| Service Note | | |
| Product | Description: | Service note no. |
| BH250 | Spacers not fastened sufficient | SNo-T0174 |

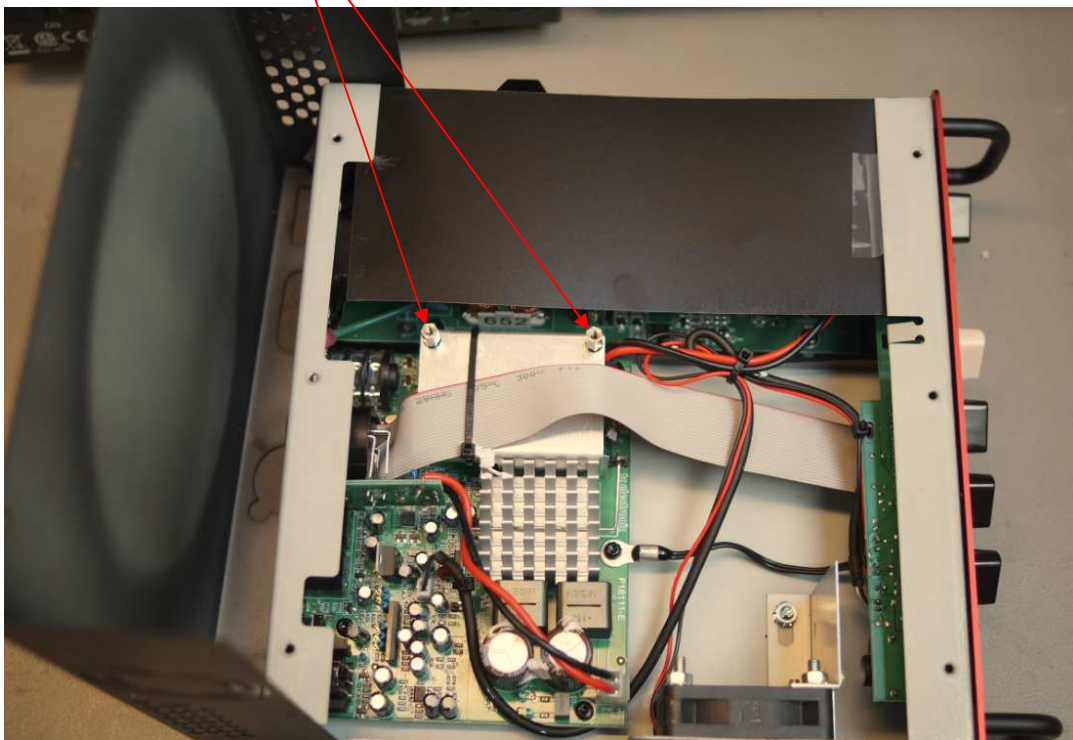
We have for a couple of production batches of BH250 sold in last half-year 2012 discovered 2 spacers and 2 screws which may not be fastened sufficient. This may cause a safety issue.

These production batches are within the following serial number ranges:

Make sure that the 2 spacers are securely fastened (torque = 65 Ncm)

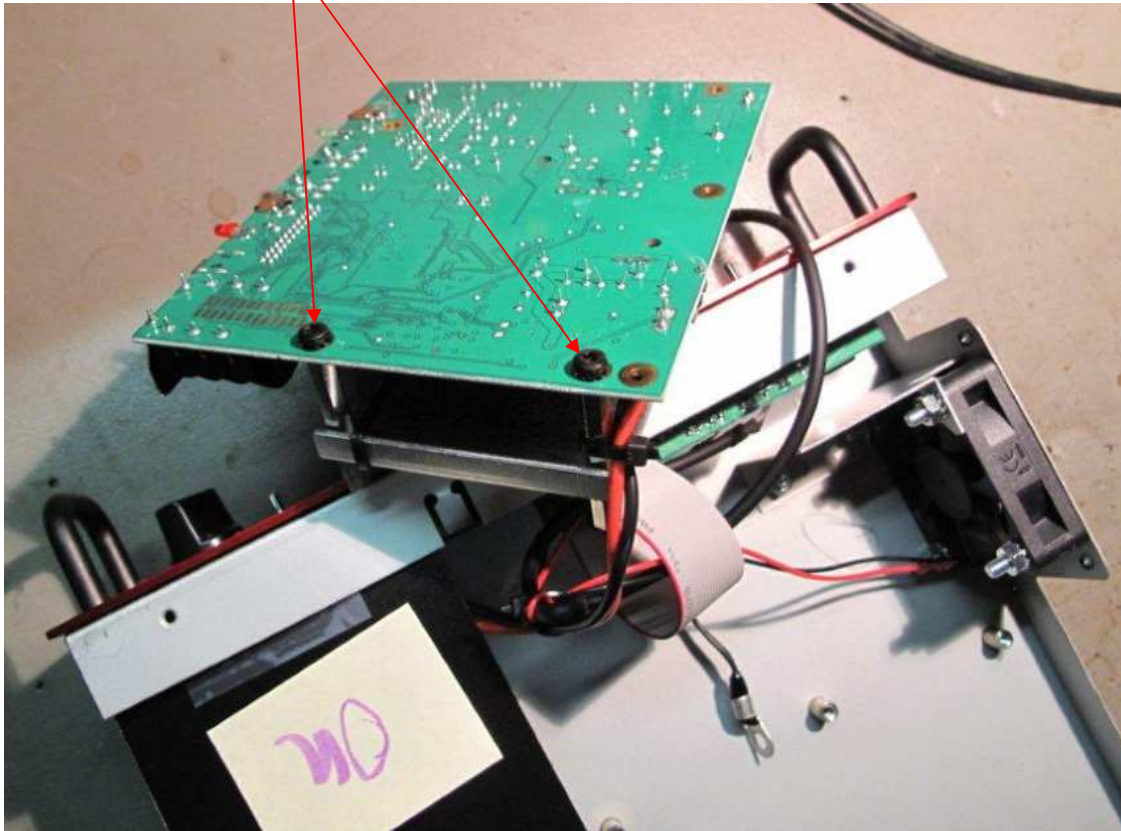
To access the 2 screws necessary to check, you have to take out the main board as shown. Make sure that the 2 screws are securely fastened (torque = 65 Ncm)

After making sure the screws and spacers are fastened correct, the main board shall be mounted again. Please pay attention that the mylar foil is placed correct.

It is recommended to place a paint mark dot or similar on the aluminium plate close to the spacers to indicate that this unit has been checked.
